Notice of Allowability

10/562,614

EXAMINER'S AMENDMENT

On page 1 of the specification, the following has been inserted between the title "ORBITAL MACHINING APPARATUS" and the heading "Background of the Invention":

Fig. 1

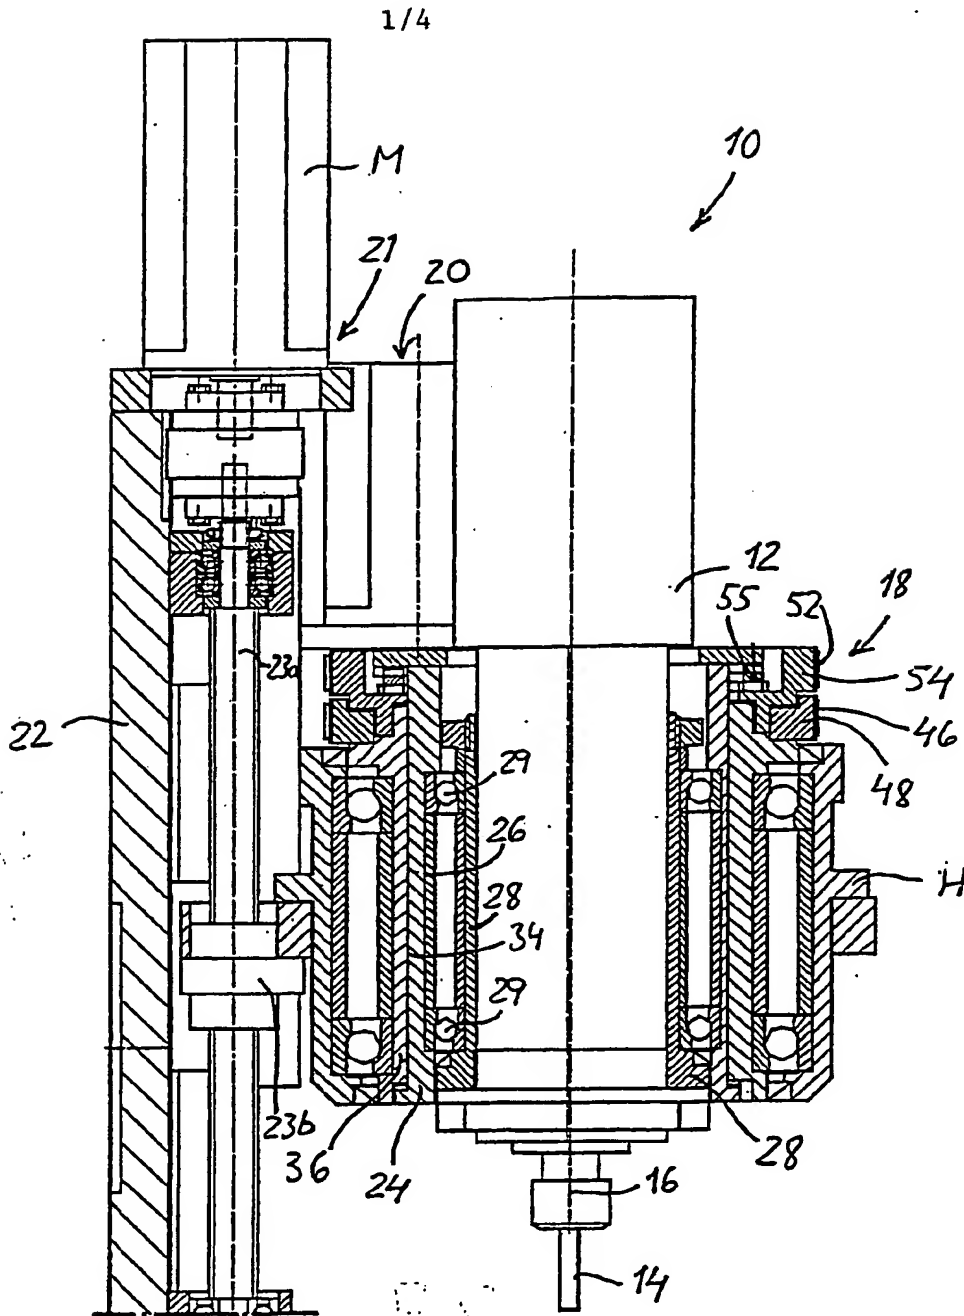
2. The following changes to the drawings have been approved by the examiner and agreed upon by applicant: the label "Prior Art" has been added to Figure 1. Additionally, Figure 5 has been relabeled as --Figure 6-- and Figure 6 has been relabeled as Figure 5. In order to avoid abandonment of the application, applicant must make these above agreed upon drawing changes.

PRIOR ART
